**DISTRIBUTION
PROJECT MANAGERS MEETING,
200 AREA GROUNDWATER and SOURCE OPERABLE UNITS
January 18, 2018**

200 AREA PROJECT MANAGERS MEETING

| Change Notice Number TPA-CN- 0802 | TPA CHANGE NOTICE FORM | Date: 11/7/2017 |

Description of Change:
Addition of 14 SE chromium plume monitoring wells and their associated sampling requirements.

Figure 3-5. Contaminant-Specific Monitoring Well Network (Tritium)

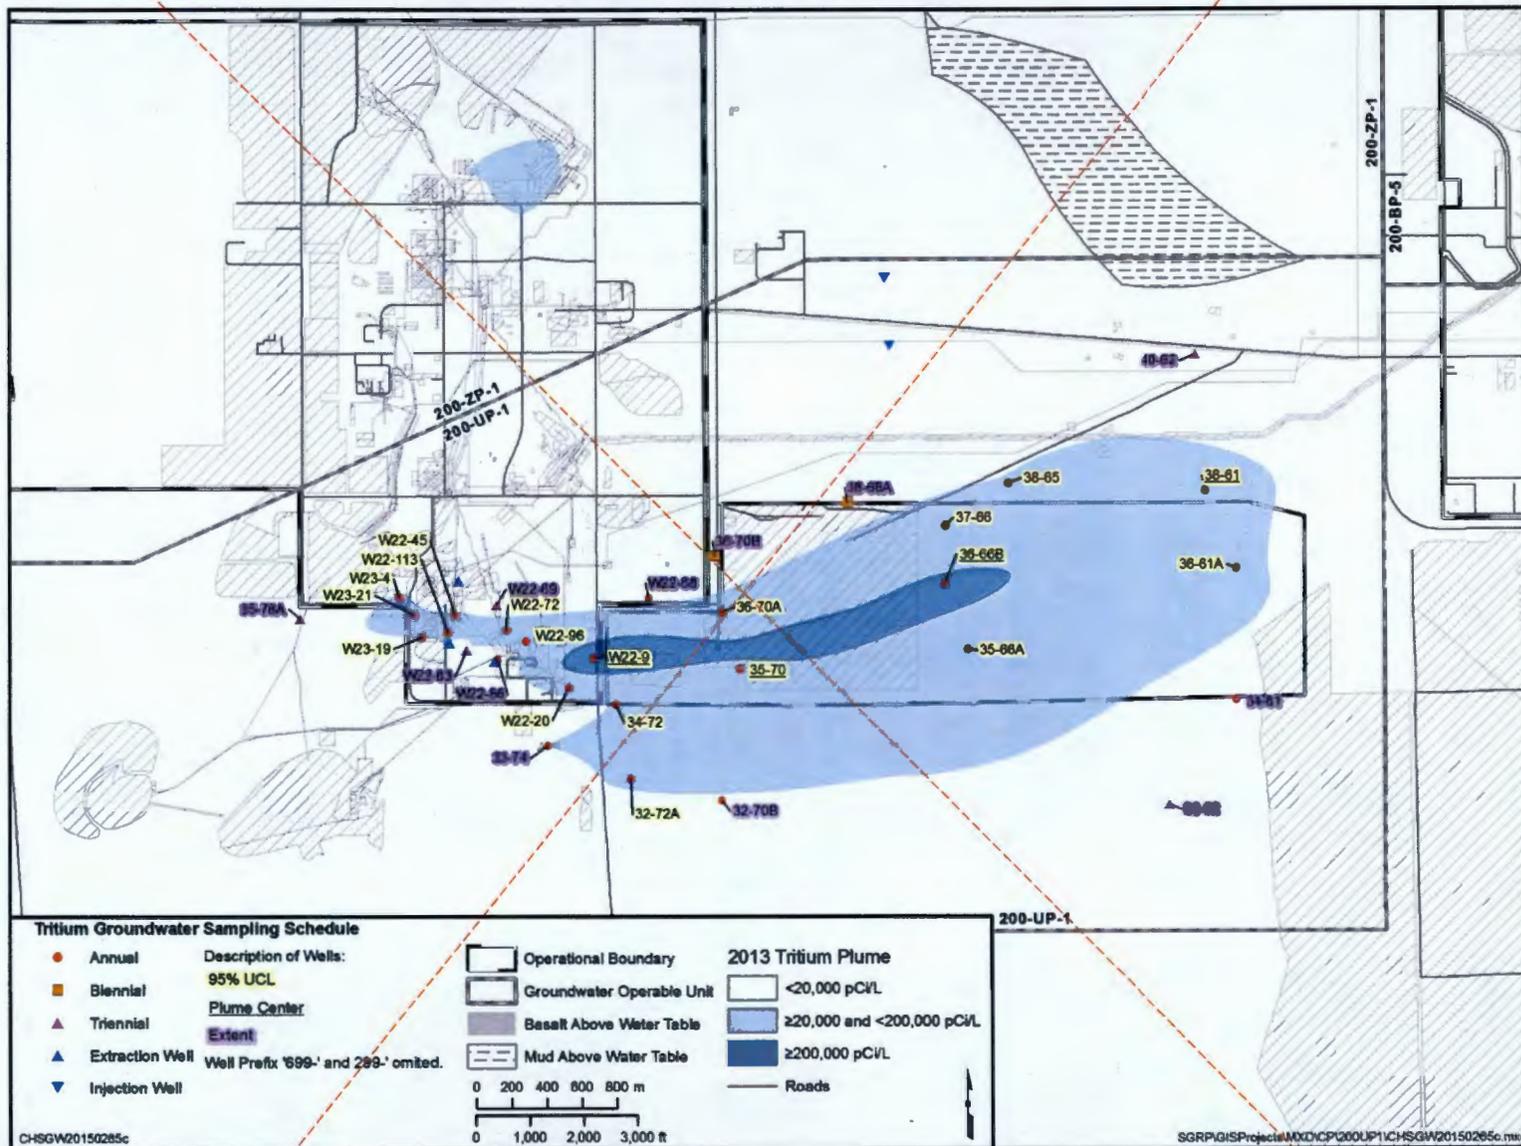
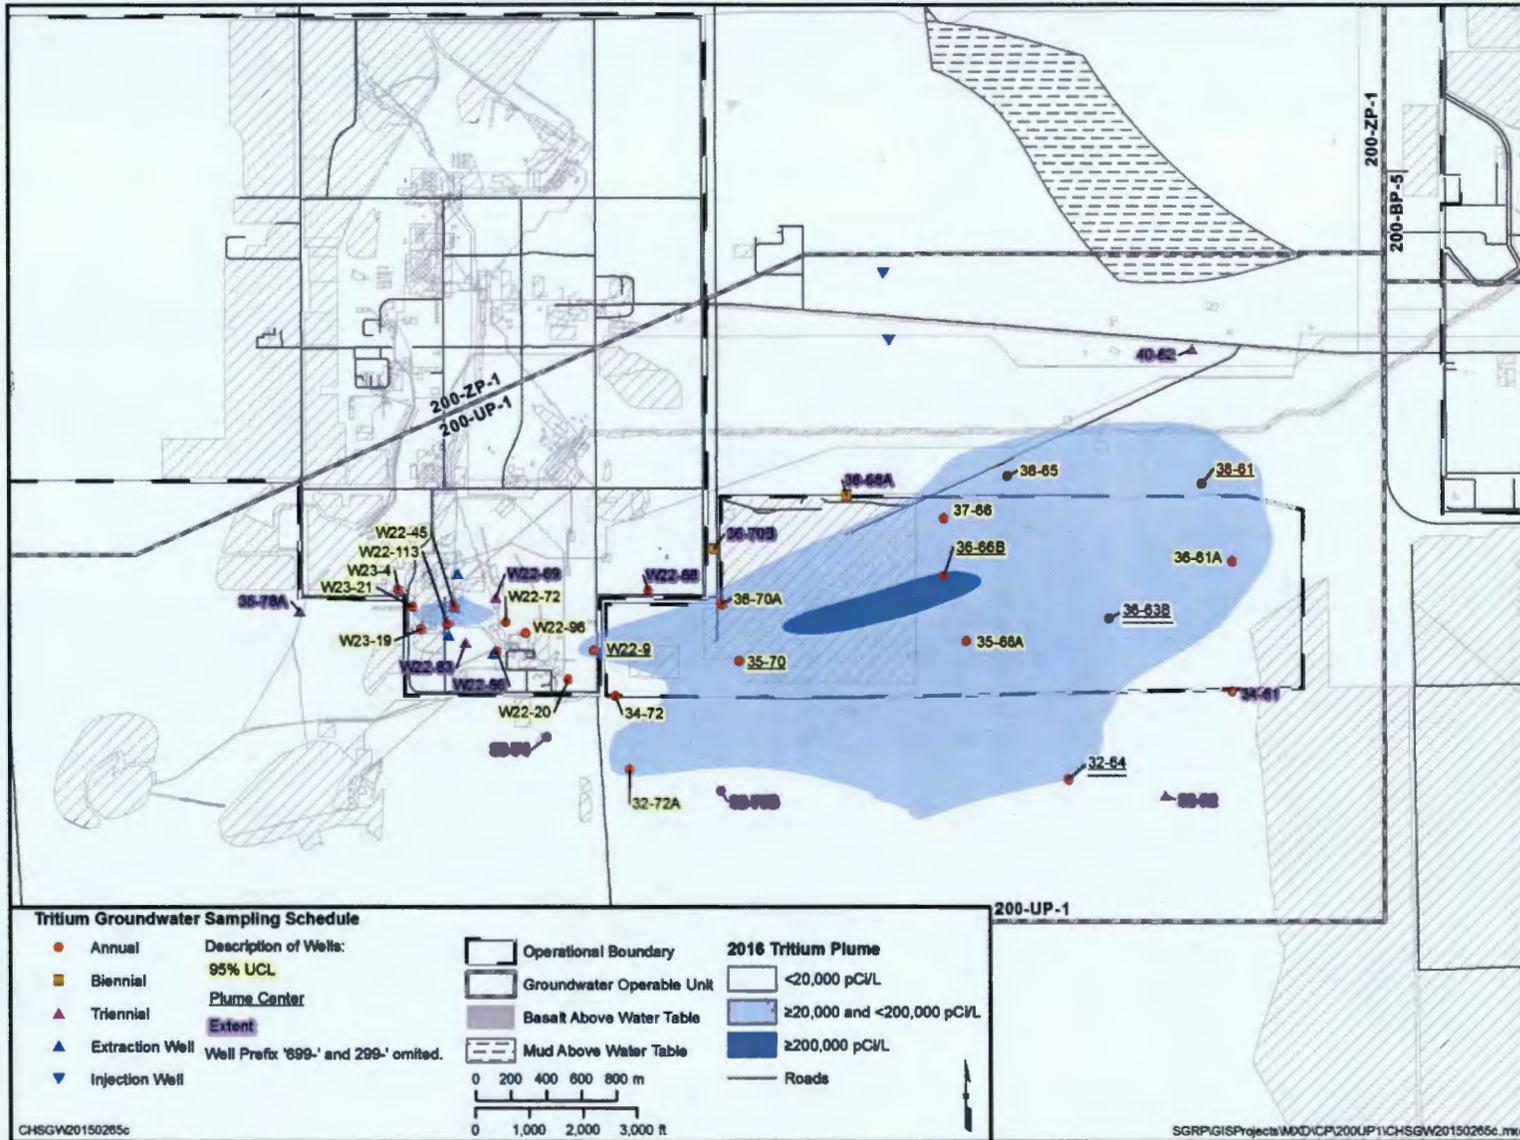
- Tables 3-1 and B-9, Well name and sampling frequency for COC and COPC's added to the tables for wells: 699-25-55, 699-25-70, 699-27-68, 699-28-52A, 699-29-55, 699-30-63, 699-30-70, 699-31-50, 699-31-53B, 699-32-59, 699-32-64, 699-34-51, 699-36-63B, and 699-30-73.
- Figures 3-1 and B-5, Wells 699-25-55, 699-25-70, 699-27-68, 699-28-52A, 699-29-55, 699-30-63, 699-30-70, 699-31-50, 699-31-53B, 699-32-59, 699-32-64, 699-34-51, 699-36-63B and 699-30-73 added to the figures. Well 699-30-73 is currently being drilled.
- Figures 3-2 and B-6, Wells 699-32-64 and 699-36-63B added to the figures.
- Figures 3-3 and B-4, Wells 699-32-64 and 699-36-63B added to the figures.
- Figures 3-5 and B-8, Wells 699-32-64 and 699-36-63B added to the figures.
